INFORMATION REQUEST

APPLICATION NO: MCUI/15/2023
PROPERTY ADDRESS: 153-161 BEENLEIGH REDLAND BAY ROAD, CORNUBIA QLD 4130
PROPERTY DESCRIPTION: LOT 12 SP 114352
APPLICATION DESCRIPTION:
• **MATERIAL CHANGE OF USE - CHILDCARE CENTRE**

Figure 1 – Length of side elevation to the west

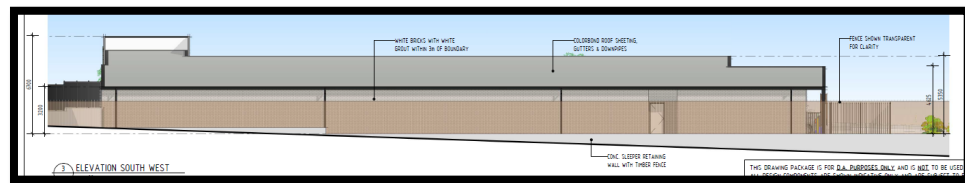
- 1.5. Demonstrate compliance with AO13.1, AO13.1 and PO13 of the Childcare centre code which seek that side boundary clearances allow for sufficient separation of buildings to ensure impacts on residential amenity are minimised and cater for dense landscaping. The proposal includes a side boundary clearance of less than 1 metre to the outermost projection (to the eaves) (submitted plans are dimensioned as 1.3 metres to wall) to the west in lieu of the 3 metres required. Despite the building being single storey, the building will span most of the length of the side boundary (refer to **Figure 1** below) and it is expected that this interface will impact on the amenity of the neighbouring dwellings. It is requested that the side boundary setback be increased to reduce visual impact to the adjoining dwellings and incorporates a landscape buffer that softens the building and contributes to an urban landscape setting.

This is further supported by AO7/PO7 of the Childcare centre code, which seeks for side boundary setbacks to be increased where building lengths exceed 15 metres.

Figure 2: Acoustic fence in area to be filled and will have retaining walls

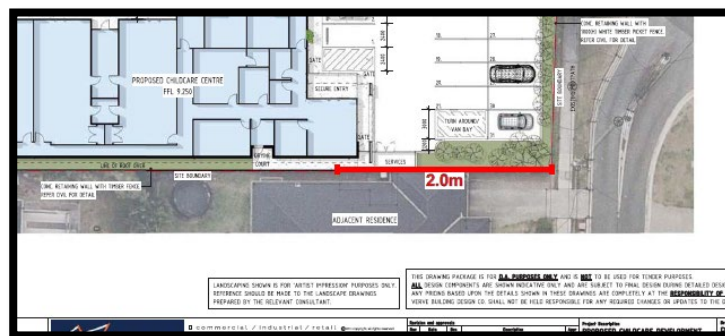
- 3.2. It is noted that the submitted plans indicate that the western boundary will have a retaining wall of up to 1.5 metres, Council officers only support a maximum combined acoustic fence and retaining wall height of up to 2 metres for non-residential development on residential zoned land. A 2 metre high acoustic fence is proposed in this location (see **Figure 2** below) and this will exceed the maximum height and could result in a total of wall/fence height of 3.5 metres to the side boundary. Council officers request that opportunities to reduce the acoustic fence height along this section of the boundary be considered, or any part of the fence, above a combined height of 2 metres be made transparent and constructed in Perspex.
